Access Compliance Report

Public Rights-of-Way

Intersection ID: 11202	Main Street: N_TRYON_ST	Cross Street: W_15TH_ST	Location: W
ADA ID: C6F51F4CE47D	Ramp Type: PerpDiag	Initial Pass/Fail: Fail	Overall Compliance: No
Severity Score: 21.25			
Codes/Mitigation Info/Possible Solution		Field Measurements/Component Compliance

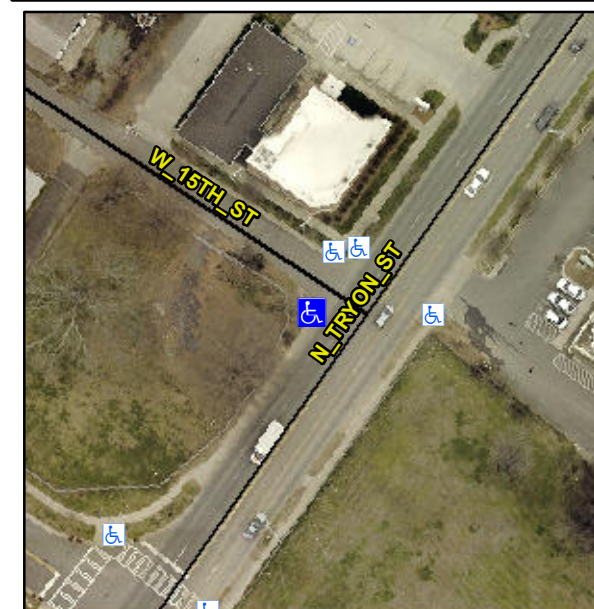
Not Found, R304.5.1, R304.2.2

Compliance	Description	Data	Compliance	Description	Data
N/A	Ramp Length (in)	64.0	No	Ramp Slope (%)	10.5
No	Ramp Width (in)	36.0	Yes	Ramp XSlope (%)	1.9
N/A	Flare Type LT	N/A	N/A	Flare Type RT	N/A
N/A	Flare Slope LT (%)	N/A	N/A	Flare Slope RT (%)	N/A
N/A	Flare Traversable LT?	N/A	N/A	Flare Traversable RT?	N/A
N/A	Landing Length (in)	N/A	N/A	DWS Provided?	N/A
N/A	Landing Width (in)	N/A	N/A	DWS Contrast?	N/A
N/A	Landing Slope (%)	N/A	N/A	DWS Length (in)	N/A
N/A	Landing X Slope (%)	N/A	N/A	DWS Full Width?	N/A
N/A	Landing Curb? (Y/N)	N/A	N/A	DWS Offset (in)	N/A
N/A	Shared Landing?	N/A			
N/A	Gutter Ponding?	N/A	N/A	Gutter Slope (%)	N/A
N/A	Gutter Lip Ht (in)	N/A	N/A	Gutter X Slope (%)	N/A
N/A	Painted X Walk1?	No	N/A	Painted X Walk2?	No
	X Walk 1 Direction	To SE		X Walk 2 Direction	To NE
N/A	X Walk 1 Width (in)	N/A	N/A	X Walk 2 Width (in)	N/A
	X Walk 1 Slope (%)	5.1		X Walk 2 Slope (%)	4.4
	X Walk 1 X Slope (%)	2.5		X Walk 2 X Slope (%)	1.6

Remove & Replace Curb Ramp With Two New Directional Ramps or Equivalent.
